Southeastern Soil & Environmental Associates, Inc.

Re: Septic system evaluation/recommendations, Woodshire Subdivision, Lot 13, Harnett County, North Carolina

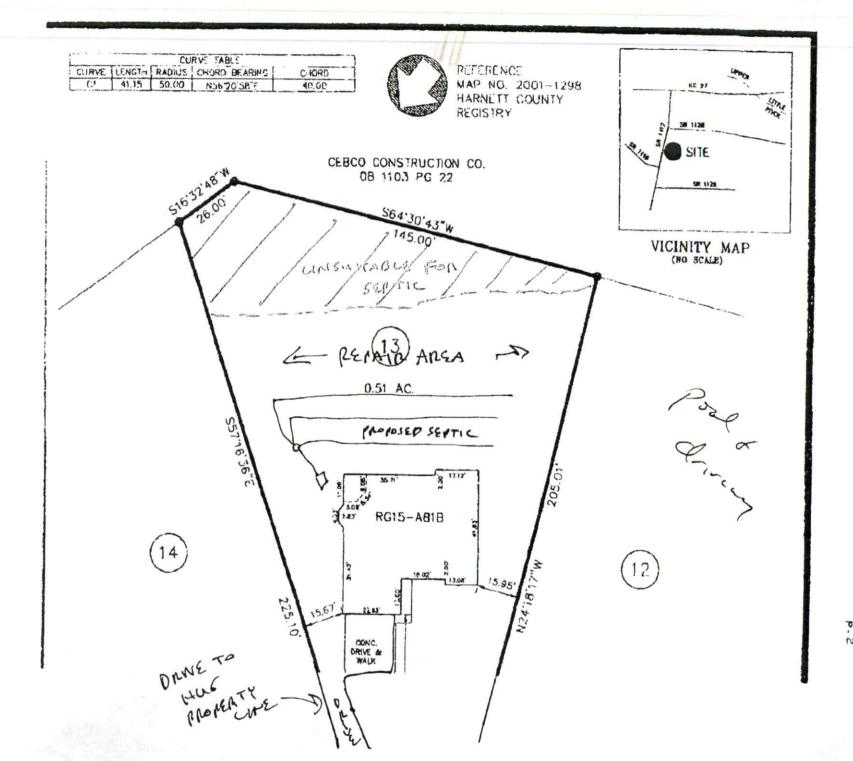
The proposed house could be located where proposed with a conventional septic system located behind the house. The only change required would be the driveway would need to be located along either lot line (typical of cul-de-sac lots).

It is my understanding, however, that the owner wishes to place a swimming pool behind the house. In order to accommodate the pool, the house would have to be shifted to the back of the lot and the system pumped to the front (in addition to moving the driveway) as proposed by the health department. The reason for this relocation is that there is a limited amount of usable soil for septic. Placing the pool behind the desired house location, would cover an amount of this limited soil thereby rendering the lot unsuitable as proposed.

The only solution would be to relocate the house to the back where the pool could be installed in unsuitable soil areas.
